City of Mississauga Department Comments

Date Finalized: 2021-11-24 File(s): A463.21

The applicant requests the Committee to approve a minor variance to allow the construction a driveway proposing a driveway width of 8.49m (approx. 27.85ft) whereas By-law 0225-2007, as amended, requires a maximum driveway width of 7.62m (approx. 25.00ft) in this instance.

Property Address: 6115 Edenwood Dr

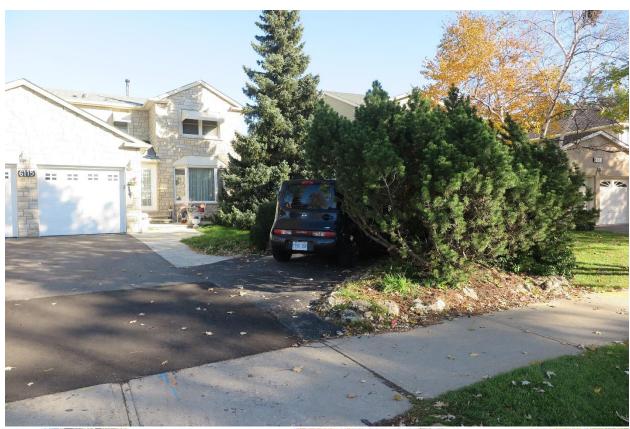
Enclosed for Committee's information are some photos which depict the widened driveway which the applicant has described as a "Hammer Head" driveway. According to city standards this "parking spot" in no way resembles a hammer head driveway.

From our site inspection and the enclosed photos we note that the widened driveway has been constructed on an angle in close proximity to the Edenwood Drive road allowance and surrounded by heavily vegetated evergreen trees/shrubs. Acknowledging that there is a municipal sidewalk in very close proximity to the widened driveway, the city must ensure that sight visibility and vehicle manoeuvrability is not impacted for any vehicles exiting the driveway for both pedestrians on the sidewalk or vehicles on the roadway.

We should also note to the applicant that even with the removal of the heavily vegetated evergreen trees/shrubs, this department would still not be in support of the request as sight visibility concerns would remain.

In view of the above we cannot support the application and would request that the widened driveway in question be reinstated with topsoil and sod should the application not be supported by the Committee.
